SN J6800A-07A

S E R V I C E N O T E

Supersedes:
SN J6800A-07

J6800A Network Analyzer

Photo #1 showing placement of mounting holes (4)

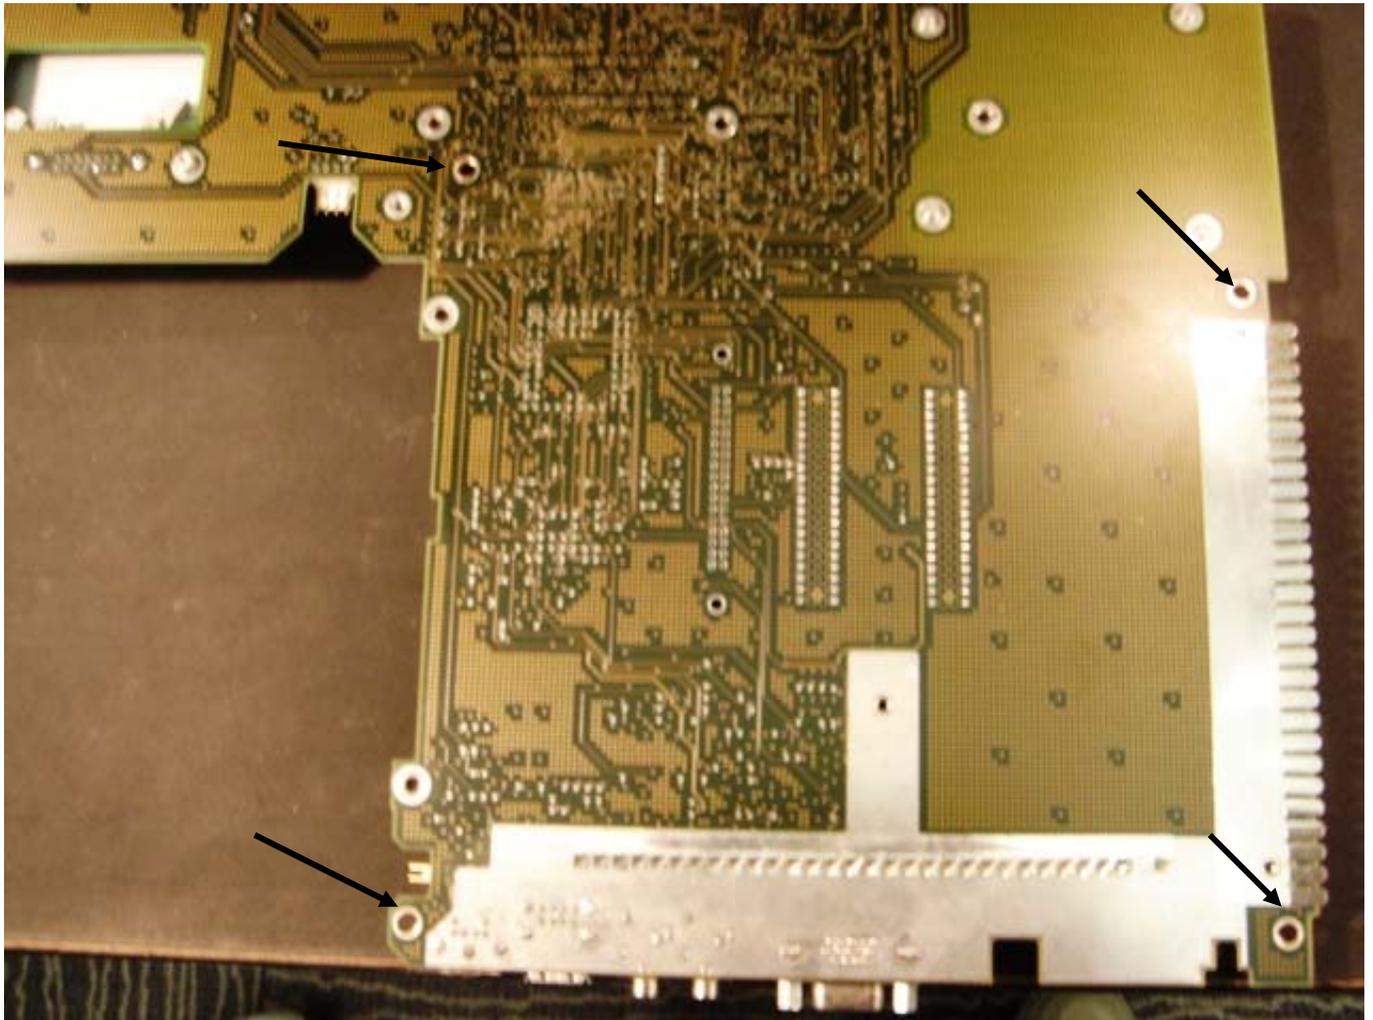
The CPU carrier card has 4 mounting holes that are used to hold the acquisition cards to the chassis. (See photo #1) After some extended period of time, the threads on these screws cuts through the plating of the hole and wears away the PCB material, exposing the copper inner-layers.(See photo #2) These exposed copper layers can short 3.3v or 5.0v to ground. This causes excessive current draw, stressing the power supply and often scorching the Host I/O power connector itself. (See photo #3)

Use washers (3050-2187) with long mounting screws when re-assembling.
